**Date:** December 22, 2011

**From:** RMT, Inc.

**Project:** State Route 35 Fiber-Fed Distributed Antenna System Project

**Subject:** Response to comments received on the Draft IS/MND

**Figure 3.1-1: Open Space Areas in the Project Vicinity**

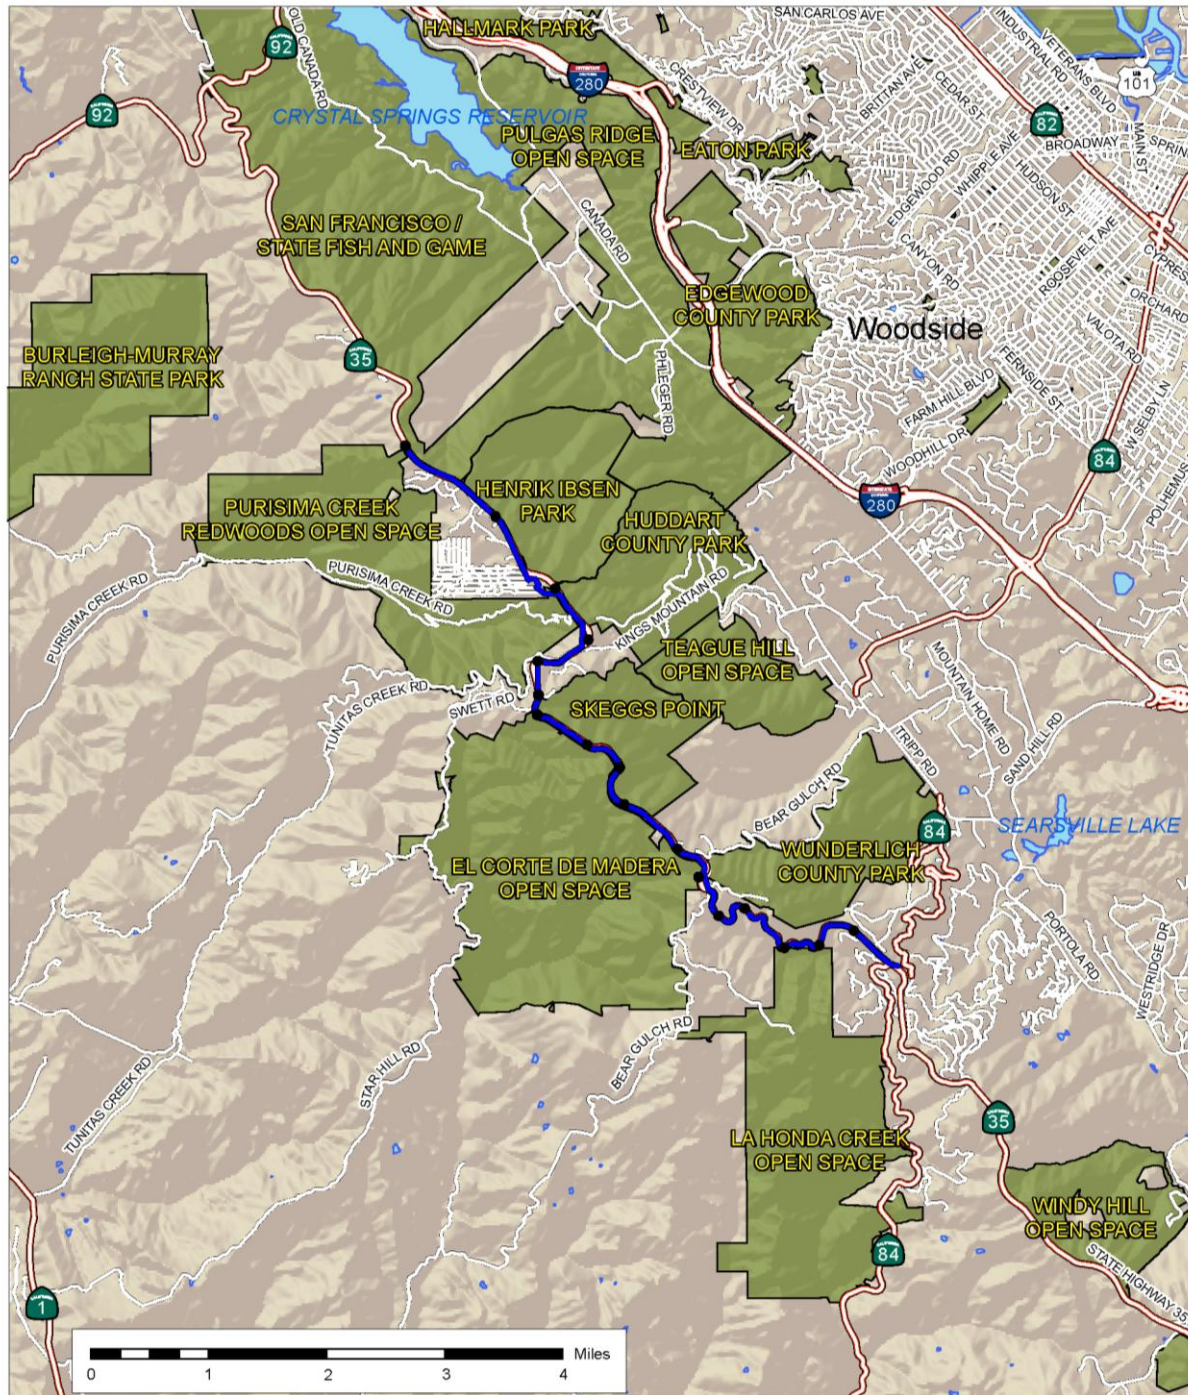
11. Provide the heights of existing and proposed poles.
12. Include the Henrik Ibsen Park and Hill Open Space Preserve on Figure 3.1-1.
13. In the event of future improvements, including maintenance and repair, to the SR 35 right-of-way wherein the relocation or removal of the fiber optic line and equipment may be required. The applicant will relocate or remove the fiber optic line and equipment at its sole expense in accordance with the Caltrans Encroachment Permit Manual Section 607.4.

12. A revised Figure 3.1-1 showing the locations of both of these parks has been attached to this memorandum.
13. The comment is noted. The applicant will comply with all requirements of the Caltrans Encroachment Permit Manual.

3. Figures 3.1-1 and 3.14-1 have been revised to include the MROSD open space lands that were omitted from the original version of these figures.
4. The text on pages 3.1-7 through 3.1-9 has been changed to clarify visual impacts to the Skeggs Point scenic vista.
